DEVELOPMENT REVIEW BOARD REPORT

SUBJECT Sereno Canyon
22-PP-2005/113-DR-2005

REQUEST Request approval of a Preliminary Plat for a 122 Single-Family residential subdivision along with the design of ancillary gate, entry and other minor common features.

**SERENO CANYON
PRELIMINARY PLAN
SITE PLAN**

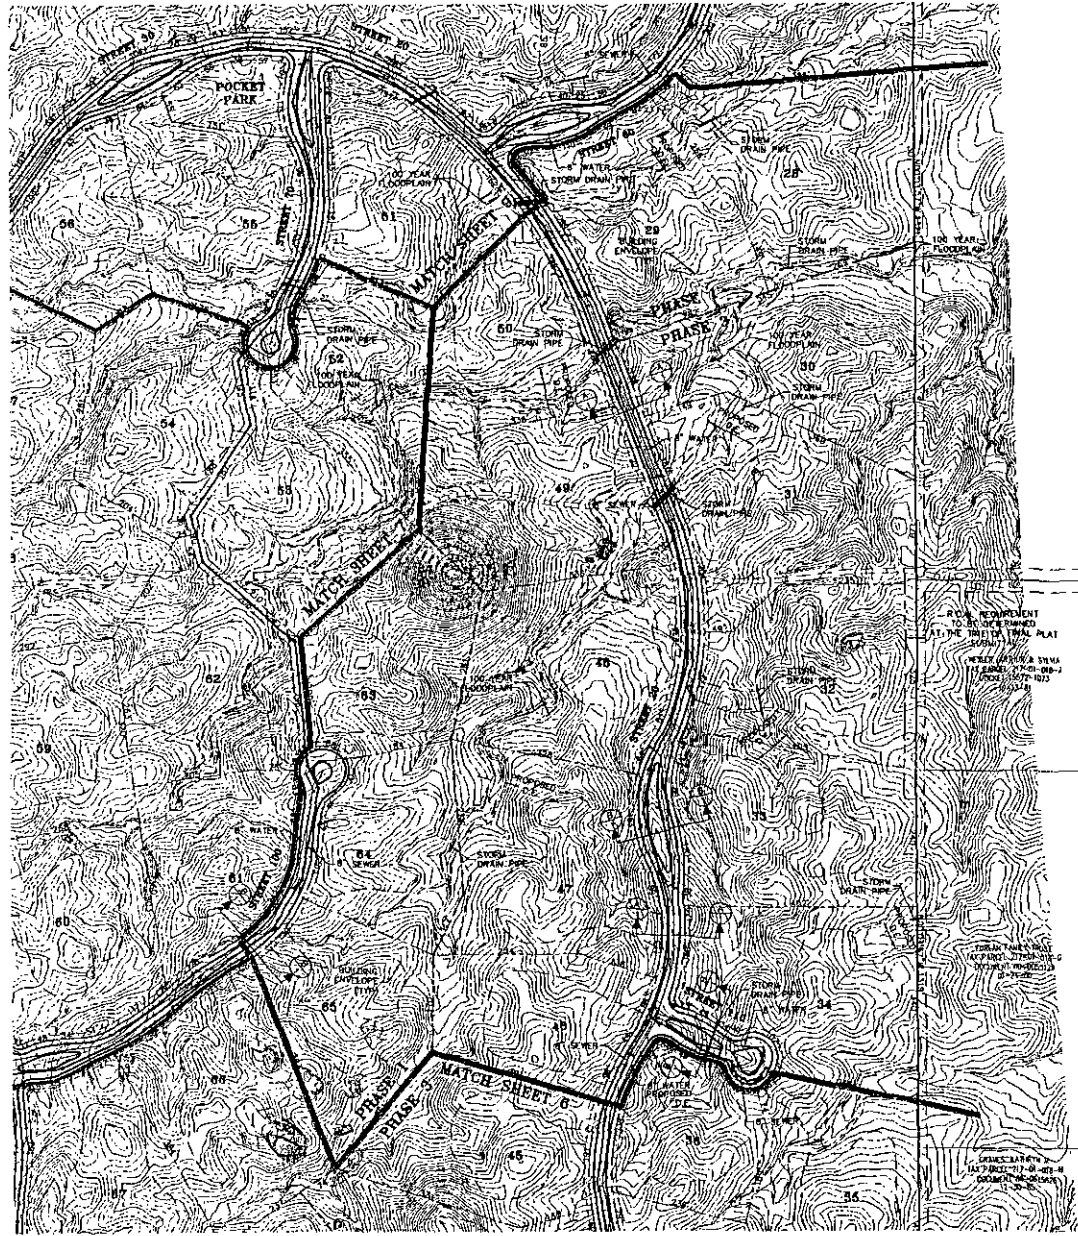
P.C. POINTMENT
 TO BE SHOWN
 ON THE FINAL PLAN
 WITH THE
 CENTER POINT & TANGENT
 POINTS

FOR THE FINAL PLAN
 THE CENTER POINT & TANGENT
 POINTS SHOULD BE SHOWN

SEE SHEET A FOR
 THE CENTER POINT & TANGENT
 POINTS
